OPERATING AND SERVICE MANUAL

VECTOR VOLTMETER 8405A

HEWLETT  PACKARD

For instruments with serial prefix above 946-, a "Manual Changes" sheet is included with this manual. The necessary changes required to adapt this manual for instruments with serial prefix 838 and below can be found in Appendix I.

Figure 7-11(b). Schematic Diagram, Phase Meter (CHANGE 17)

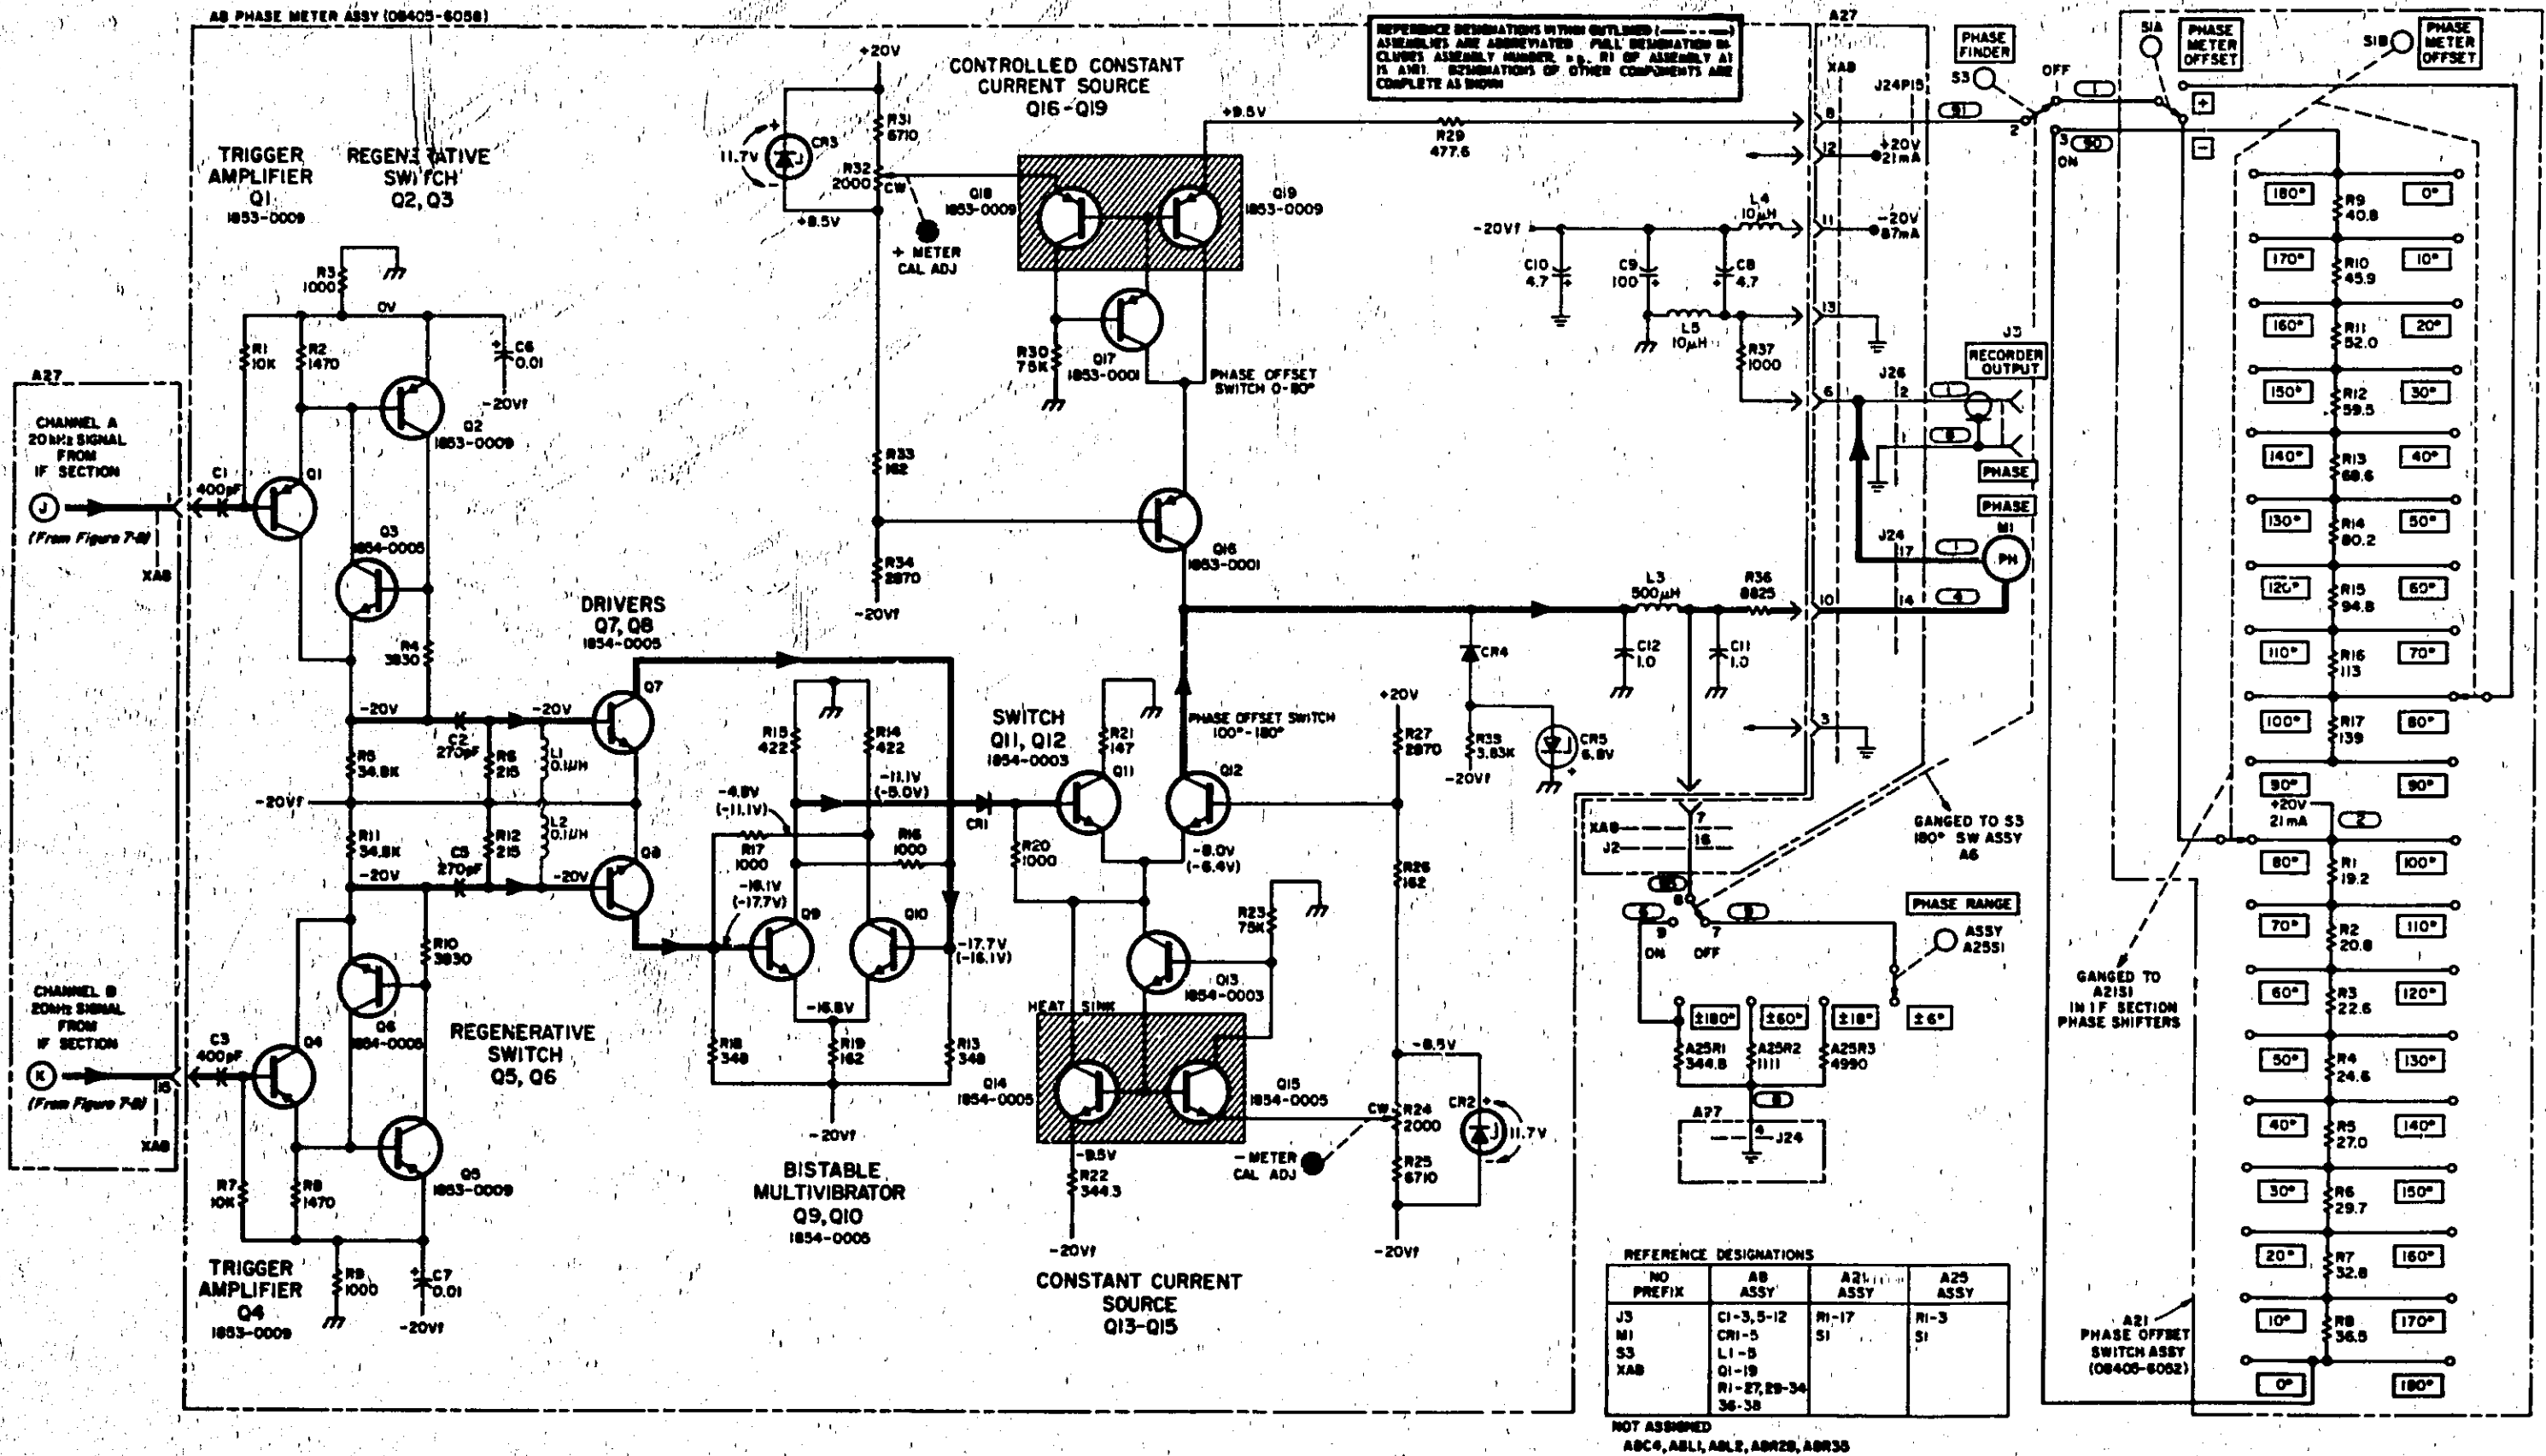
Change Figure 7-11(b) of Change 17. In the lower left corner of the replacement page, the A21 Phase Offset Switch Assy is identified as part number 08405-6052. Replace the part number with this note: See Table 6-1 for current assembly number.

Change Figure 7-11(b) of Change 17. In the lower left corner of the replacement page, the A21 Phase Offset Switch Assy is identified as part number 08405-6052. Replace the part number with this note: See Table 6-1 for current assembly number.

Figure 7-13(b), Schematic Diagram, Voltmeter (CHANGE 17)

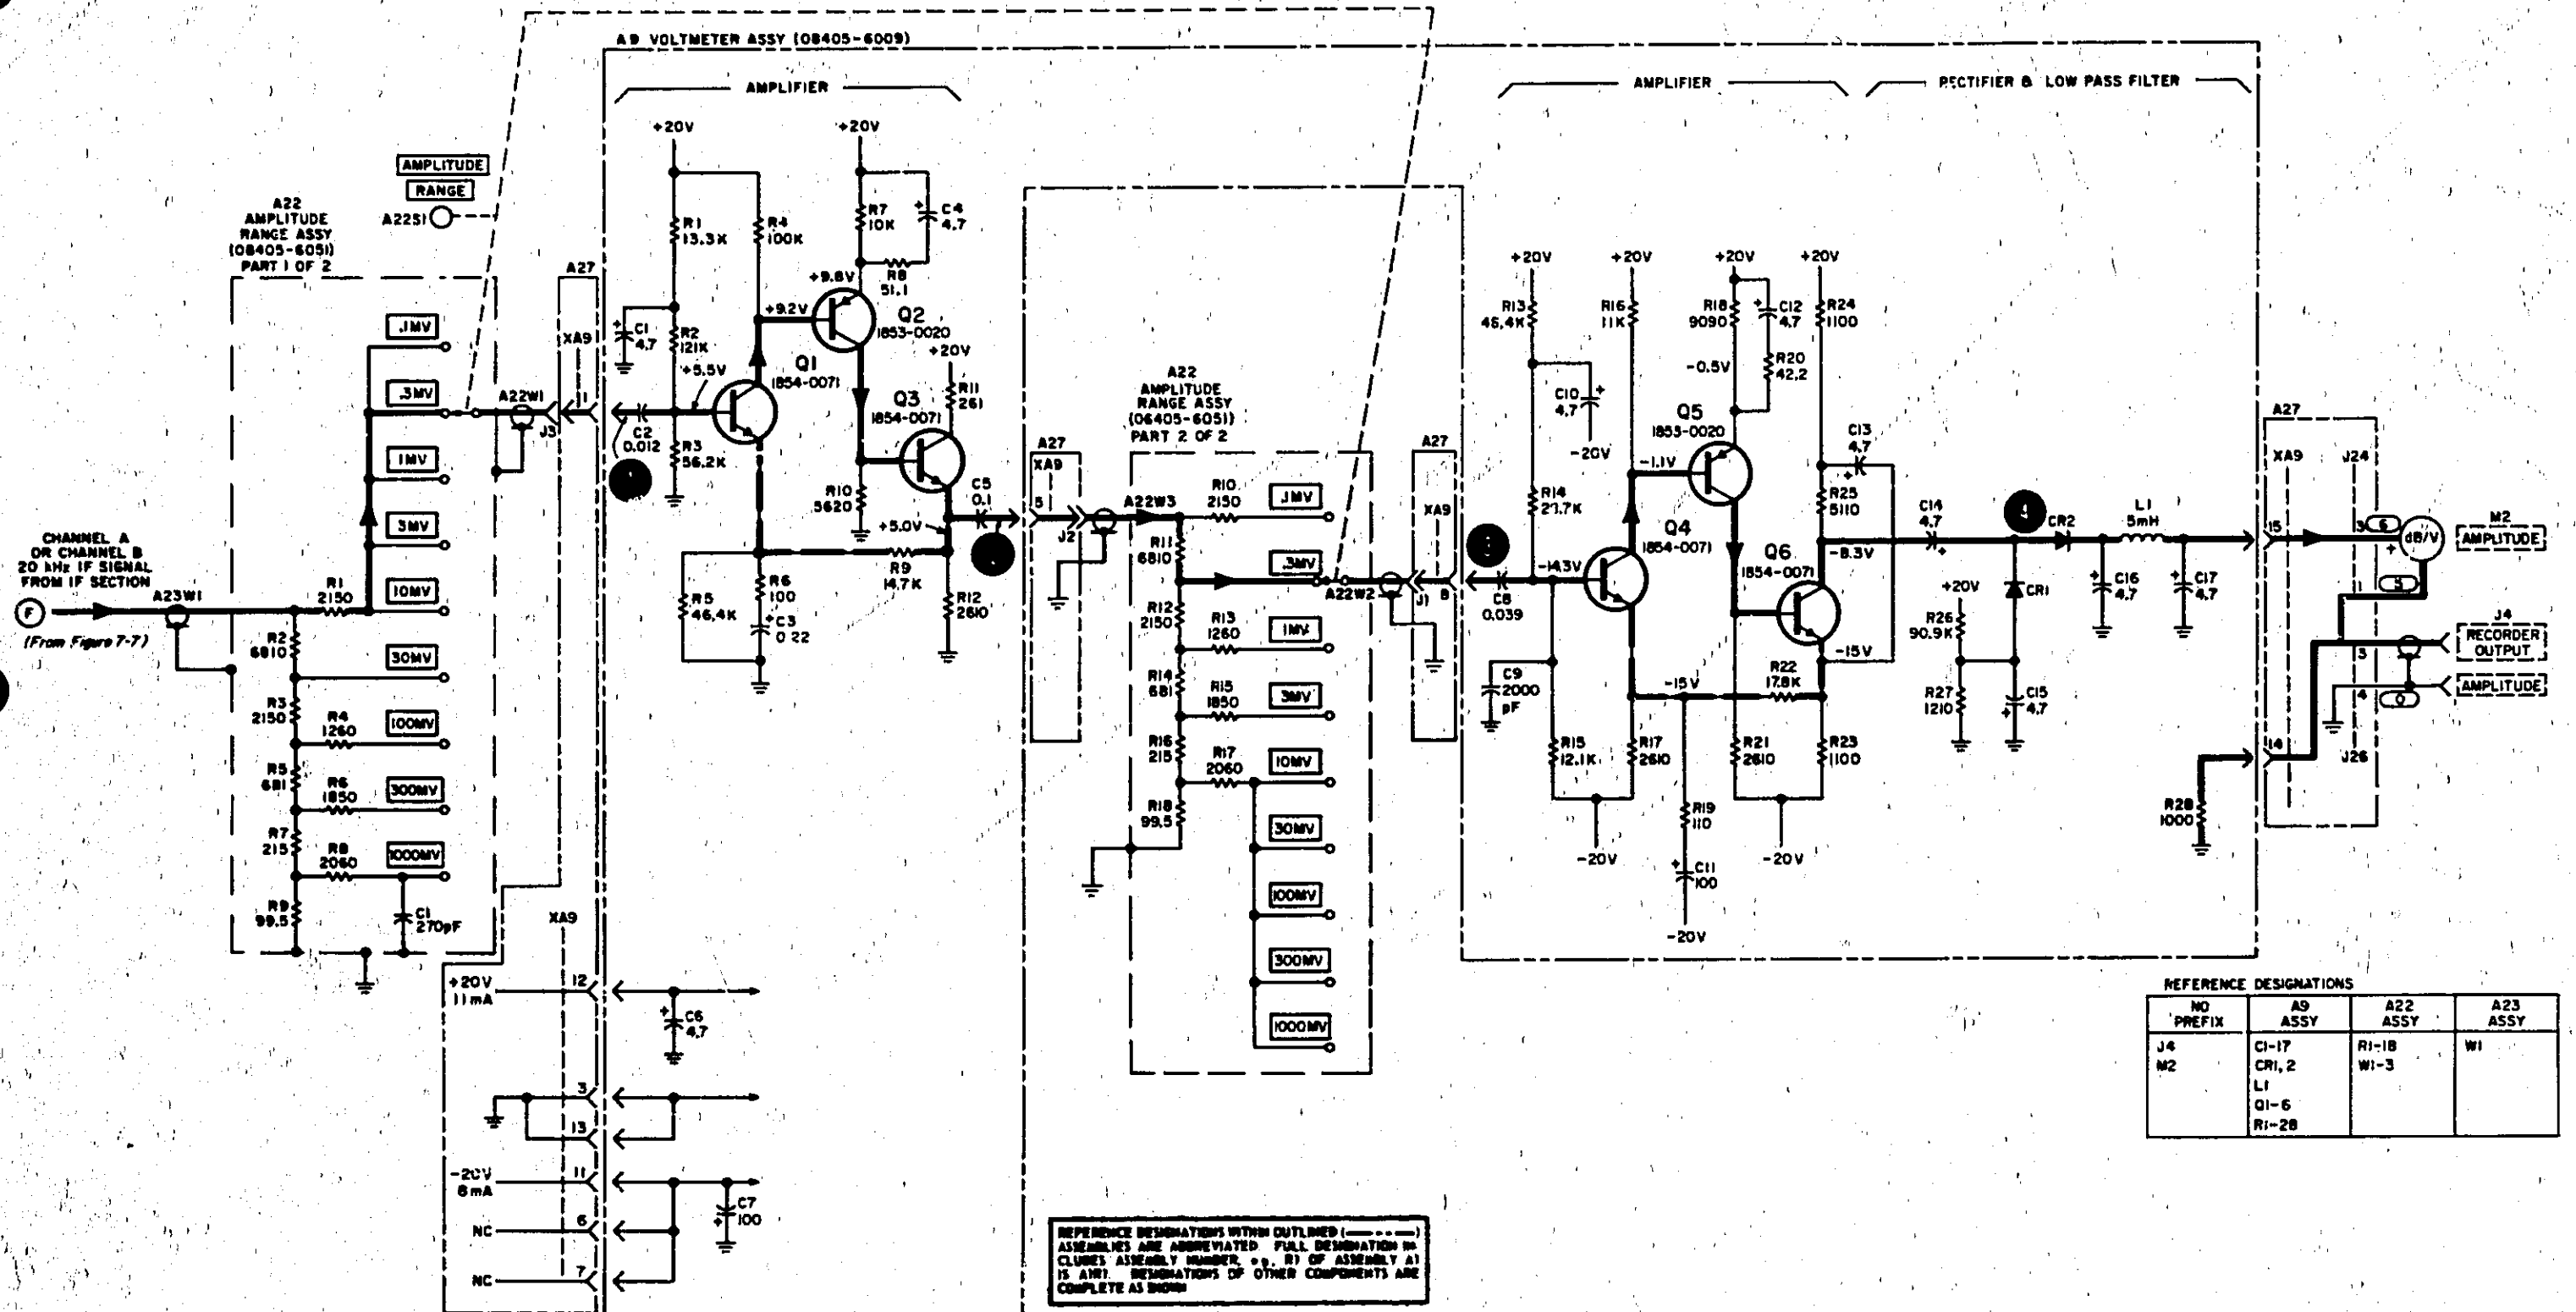
Change Figure 7-13(b) of Change 17. The A22 Amplitude Range Assy is identified twice as part number 08405-6051. Replace the part number with this note: See Table 6-1 for current assembly number.

Change Figure 7-13(b) of Change 17. The A22 Amplitude Range Assy is identified twice as part number 08405-6051. Replace the part number with this note: See Table 6-1 for current assembly number.

Figure 7-17(b), Schematic Diagram, Automatic Phase Control Section (Part 2) Sampling Pulse Generator (CHANGE 17)

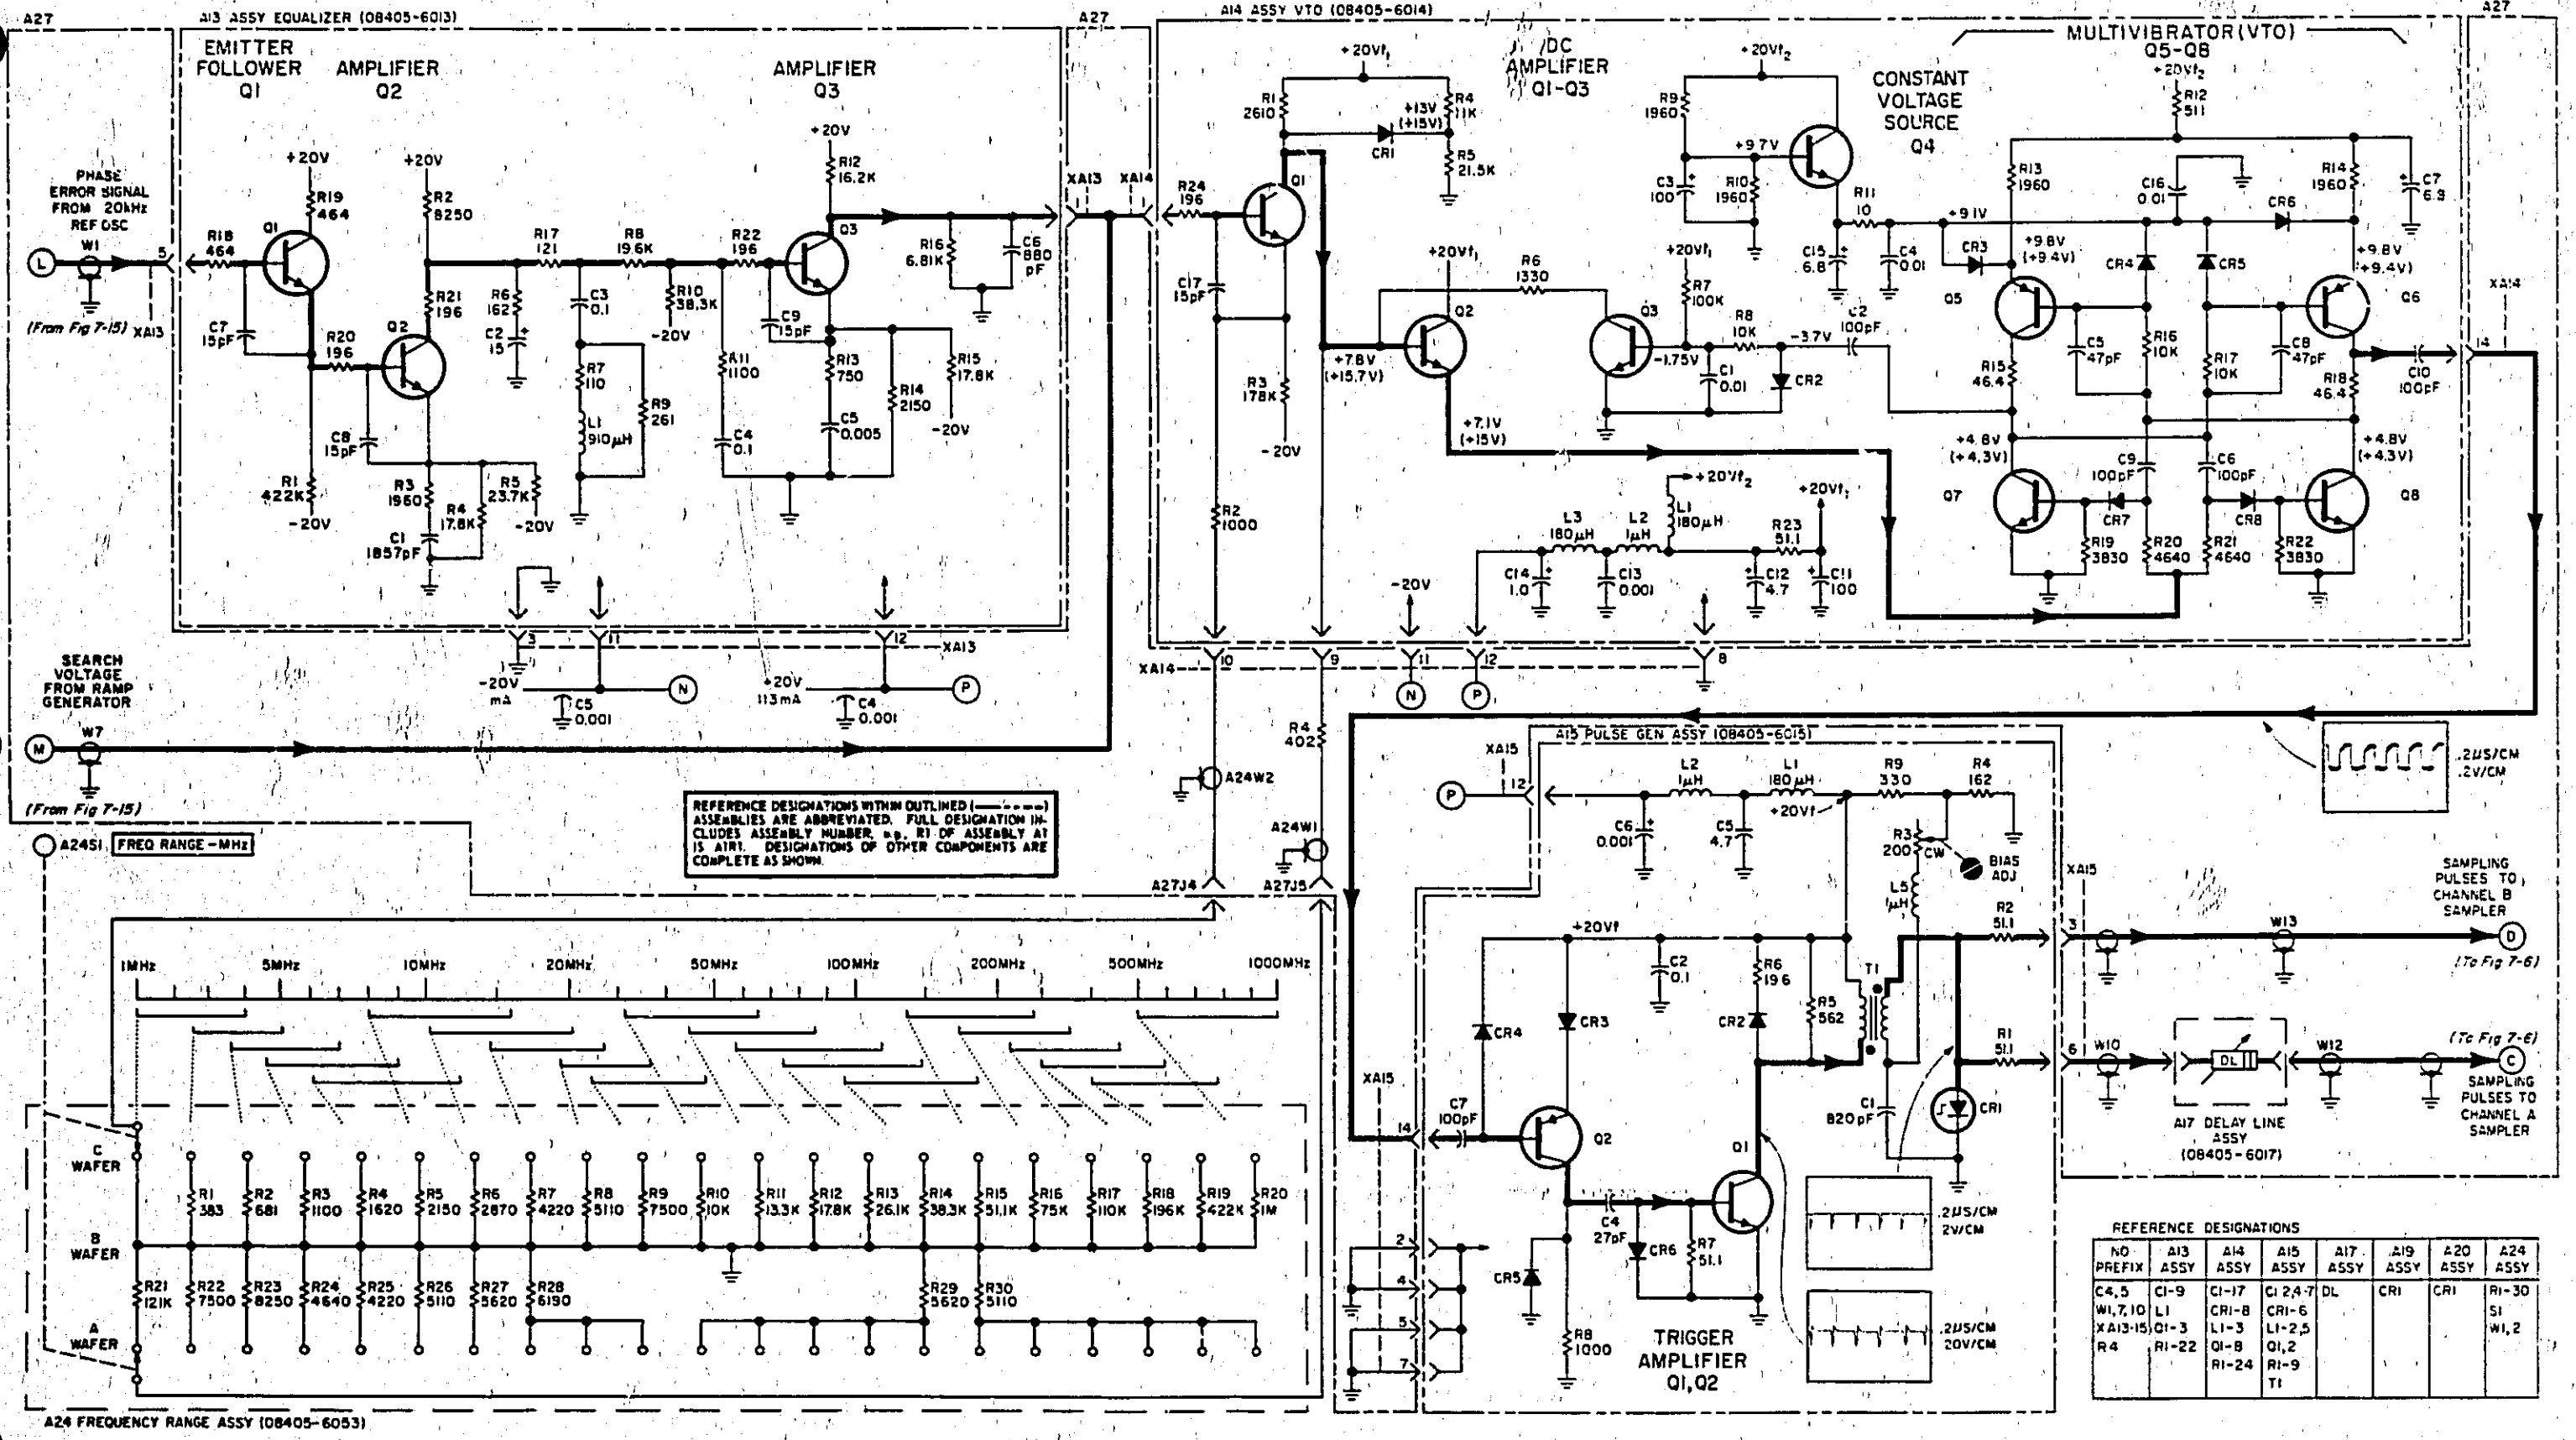
Figure 7-17(a):
Replace the part number 08405-6053 which identifies the A24 Frequency Range Assy with this note: See Table 6-1 for the current assembly number.
Figure 7-17(b) of Change 17:
Replace the part number 08405-6053 which identifies the A24 Frequency Range Assy with this note: See Table 6-1 for the current assembly number.
